Greggs Bakery / Twickenham
Design Statement – Planning Addendum

1.1 The purpose of this document

This Design and Access Addendum has been prepared to identify and explain changes to the planning submitted scheme (ref: 19/0646/FUL). These changes have been made in response to further consultation post submission of the application including at a Design Review Panel, discussions with the London Borough of Richmond and consultation with local residents.

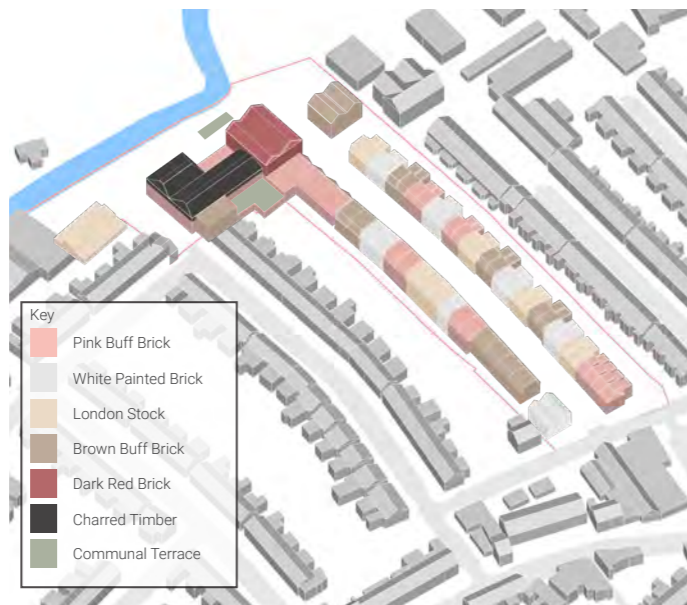
A number of comments expressed concern that the scheme was incongruent with the area in terms of height and character. They expressed that proposals should not exceed 4 storeys.

Further, since the application and through further consultation we have revised the external material of the four storey element and reduced the roof pitch and parapet heights to reduce its impact on the surrounding streets. This is shown on the images to the right expanded on later in the document.

The height of the proposals has been a material consideration throughout the design process and was further revised following consultation before planning submission. This included:

The tallest building is a modest five storeys towards the north of the site. This matches the approved student accommodation building less than 40 meters away. It is also similar in height to the apartment buildings on Langhorn Drive across the river. We understand residents are concerned about this height which is why the four and five storey building have been positioned where it will have minimal impact on the surroundings, with no effect on sunlight to neighbouring properties nor does any residential building look directly towards them.

Planning submitted material proposal

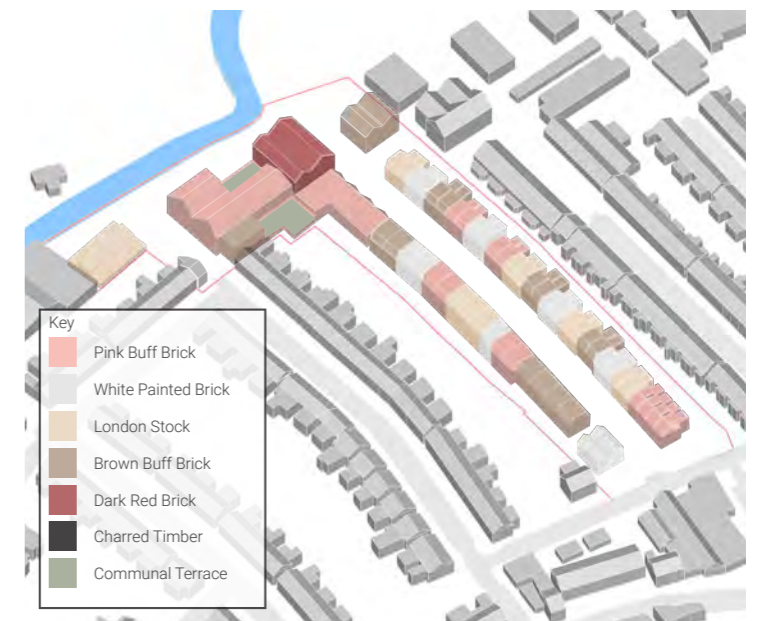
Some of the comments raised related to the character of the proposals and questioned whether they are in keeping with the area.

Careful analysis was undertaken on the surrounding residential streets to ensure that the character of the proposals are derived from their style. So that the site was not treated as one single development which could have become over bearing the design was split into three character areas. This helped increase variety and allowed the development to respond to the changing context at opposite ends of the site.

As part of this addendum the proposals have been adjusted to further fit into the townscape through a change in material to Building F's upper floor and roof.

Planning submitted landscape proposal

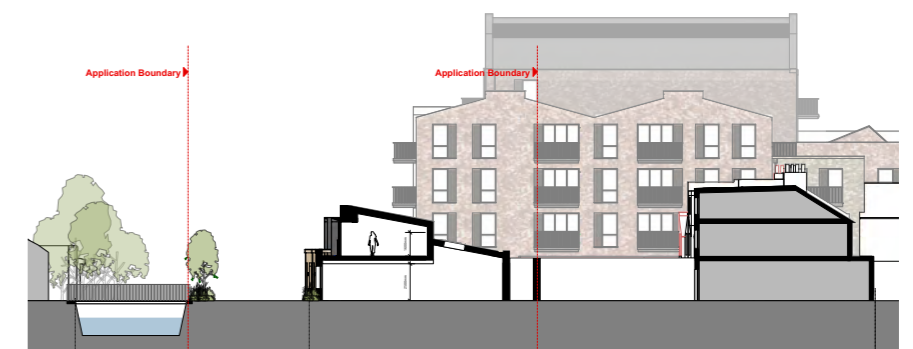
Supportive of the clear public realm concept, however the location of car parking at the north end of the site and overall quantum could be reduced to improve the landscaping and river edge. Little space is left for seating, play and recreation. Consider mitigation measures to soften the hard edge towards the river-front and create a sense of place by the river edge.

The space for the bridge landing feels compromised with car parking and play-space. Suggest taking forward the opportunity for a pedestrian crossing over the River Crane and the railway and interrogate this space to ensure sufficient landing area. Losing the four houses may help assist in improving this.

Accommodating sufficient parking and appropriate landscaping has been a careful balance. Following discussions with our transport consultant we propose the removal of 15 parking spaces to enhance the landscaping with further measures as follows:

- Greatly enhanced river edge treatment with extension of board walk and play space;
- Reduced car parking results in a portion of 1 bedroom apartments not allocated a parking space;

- Detailed design of playspace and bridge landing showing how these interact and ensuring the space is sufficient;
- Future-proofed bridge landing with additional safe guarded area added to planning submitted drawings;

- 100 metre board walk runs the full length of the river providing further opportunities for interaction and play;
- Increased planting buffer improves biodiversity and reduces light spill onto the river corridor;

- Spaces for seating, play and walking provided;
- Clear delineation between car and pedestrian spaces;
- Four houses proposed to the rear of Gould Road houses to be retained as previously submitted. These houses have been designed to fit comfortably in front of the playspace, provide natural surveillance enhancing the security of the riverside area and avoid overlooking to neighbours.
